May 21, 2020

**Re: Permit No. M-1980-244; Cripple Creek & Victor Gold Mining Company; Cresson Project; –
Technical Revision 121 Preliminary Adequacy Review Response**

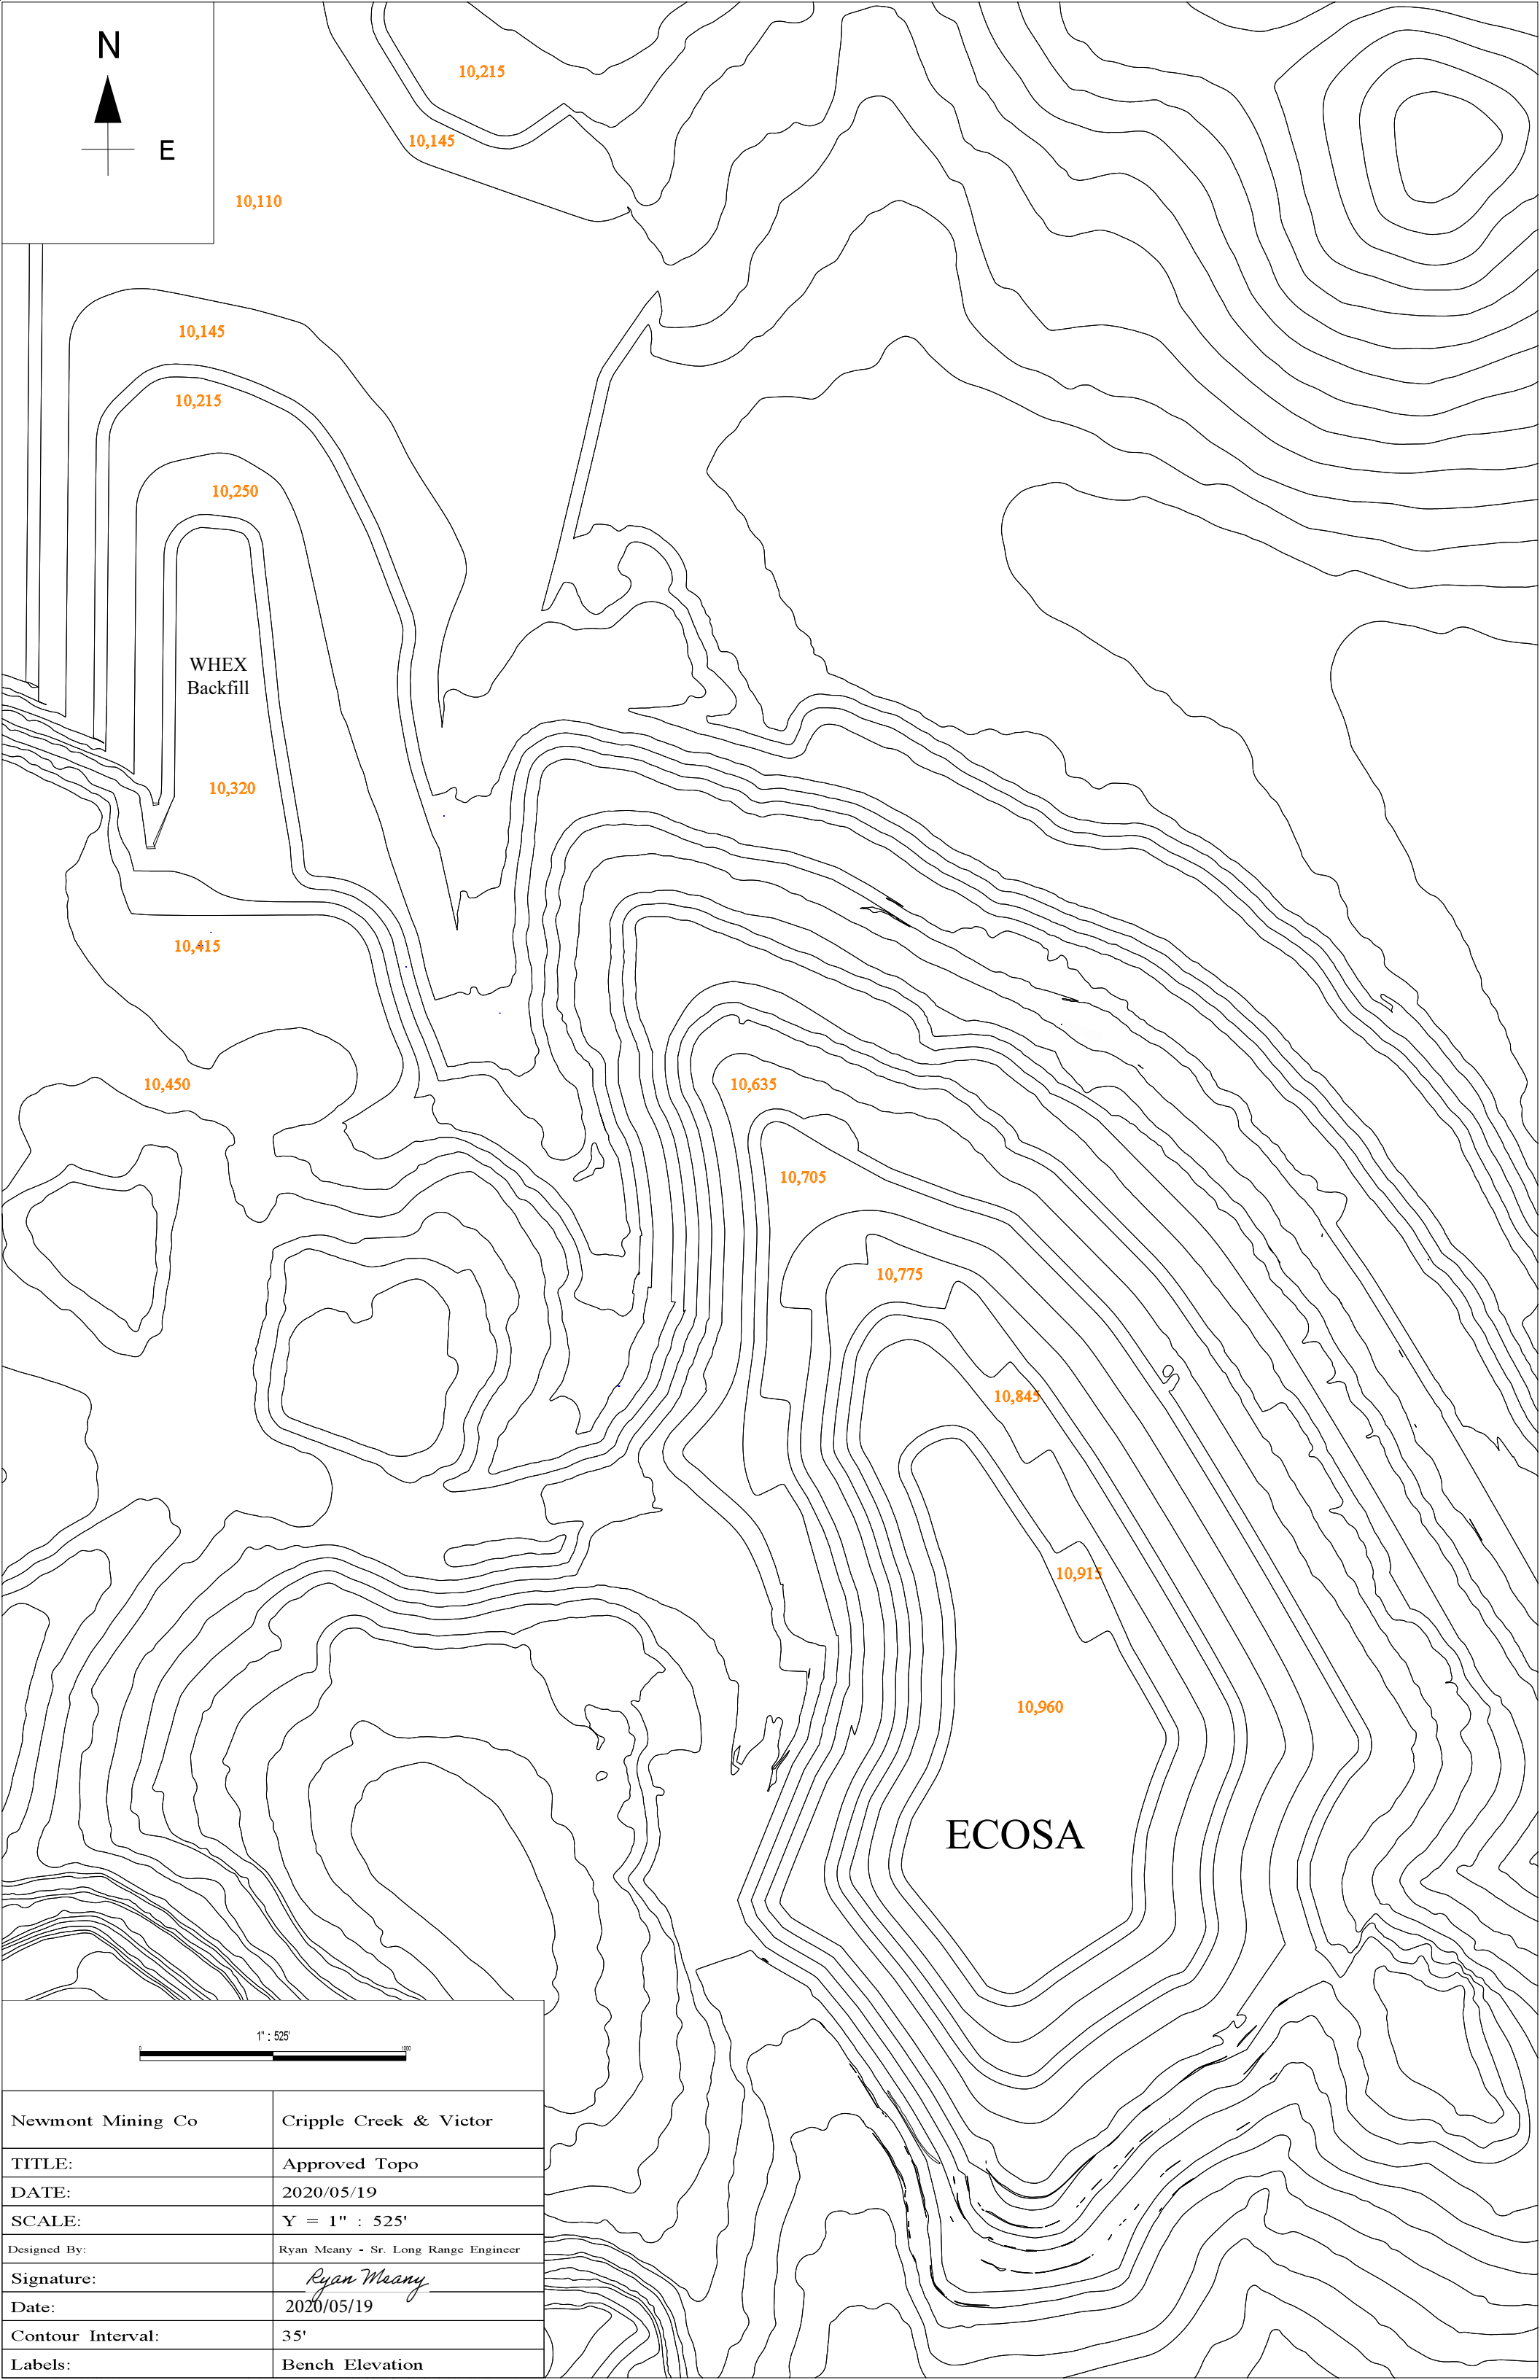
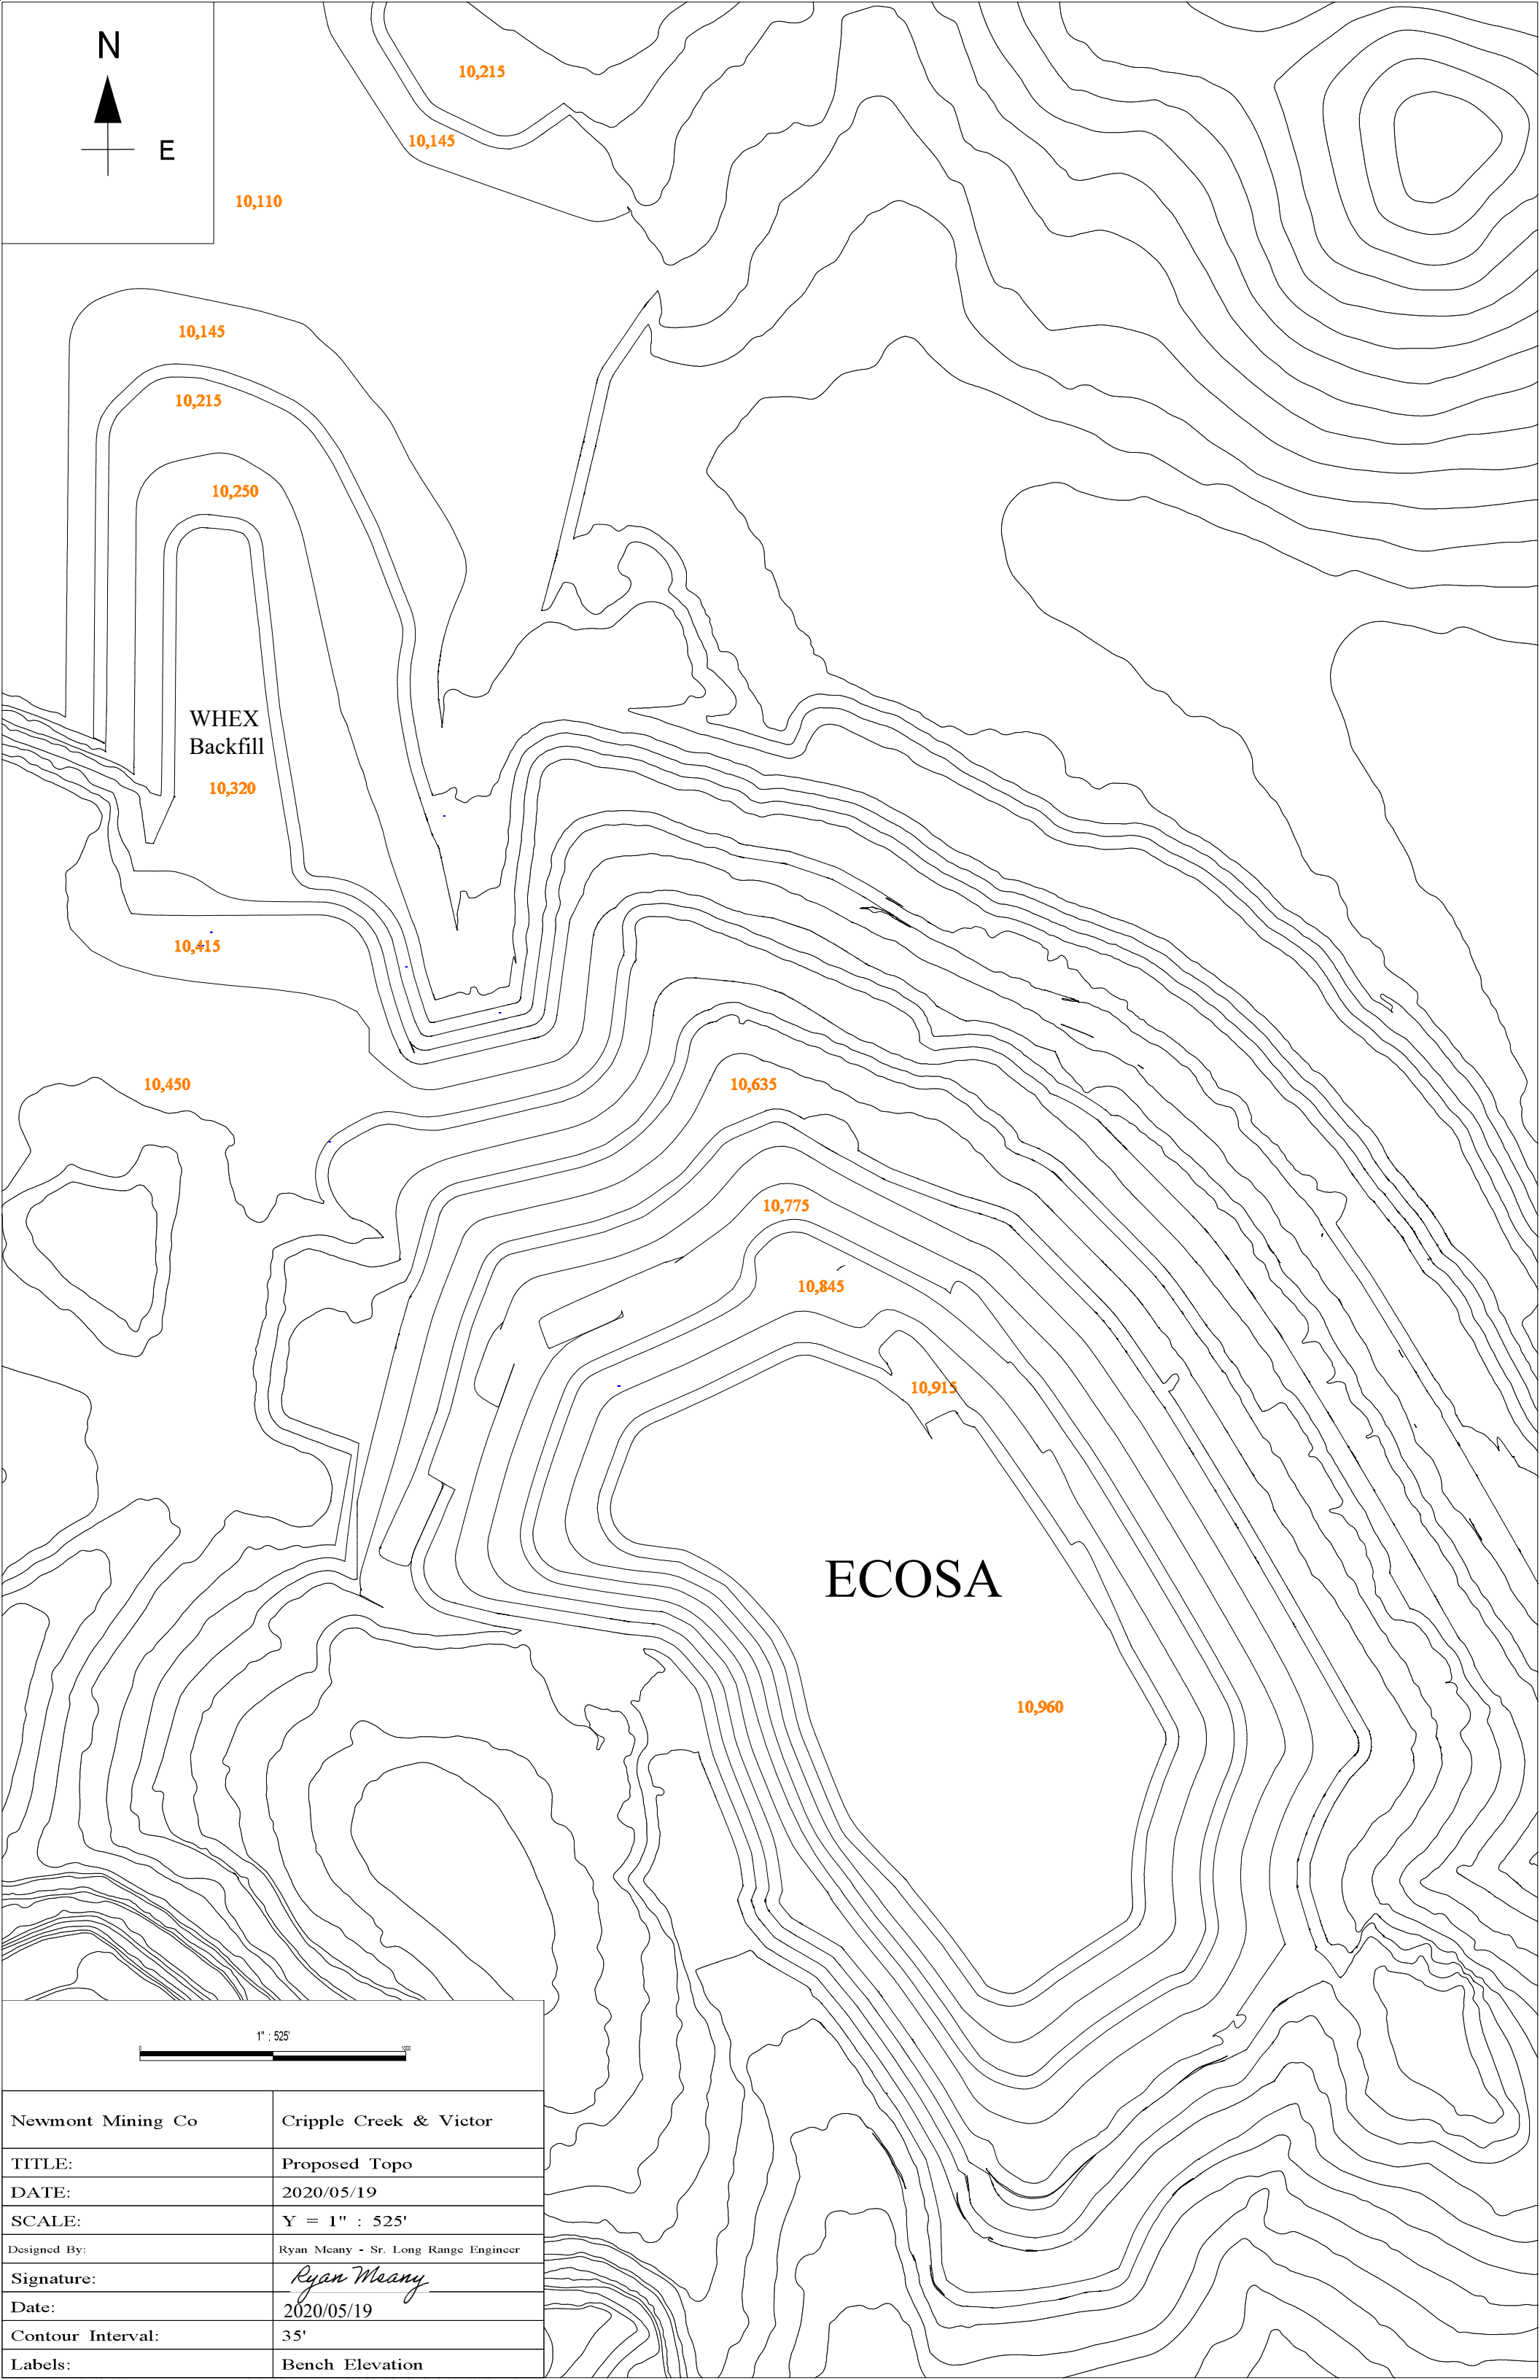
- 3) *Figures/Drawings: The provided drawings may be appropriate for internal mine planning, but more information and clarification are necessary to convey the full intent of the proposed changes. For example: there are no legends on any of the figures/drawings as required by Rule 6.2.1; and there appear to be inconsistencies with drawings submitted as part of AM-13 (which the Division is currently reviewing). Attached to this adequacy letter are markup versions of the four submitted drawings. Please revise the four drawings accordingly.*

Enclosed in this response, Figures 1-4 have been updated to address DRMS comments.
